TECHNICAL BULLETIN

CHANGE OF OEM SAF SKRS BRAKE DRUM DESIGN

OEM PART No.: 1064026000, 1064026001, 1064026002, 1064026012, 10640260020

WINNARD PART No.: SAU1011

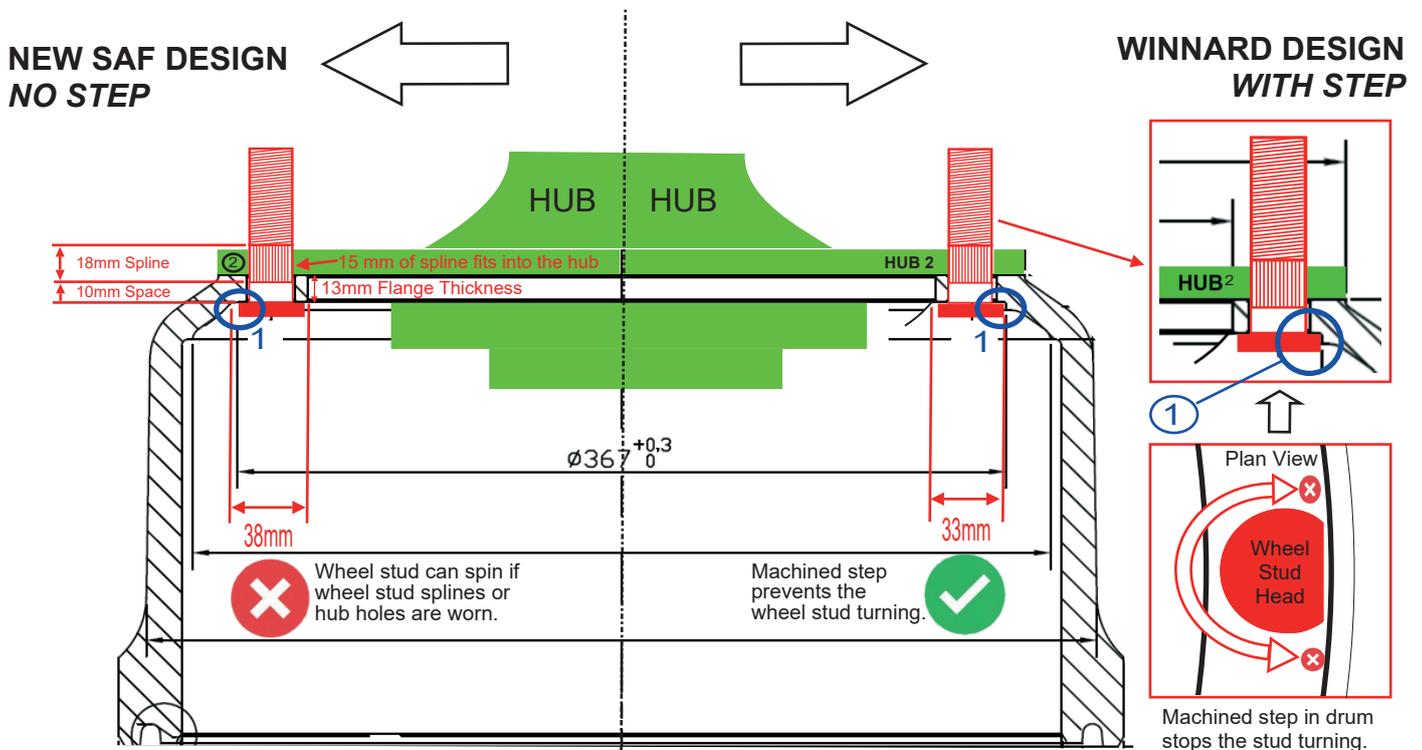
SAF has changed the design of this brake drum. The stud location step on the underside of the stud face has been removed, see area (1) in the illustration below. The wheel stud is designed to have an interference fit into the hub (2). The location step in the old brake drum design helped to prevent the wheel stud from rotating as its interference fit into the hub loses resistance.

We understand this change has been made to prevent unsuitable, worn, components from being re-used.

Winnard will continue to supply the old design with the stud location step but the new design is also available, our part number is SAU1011NS.
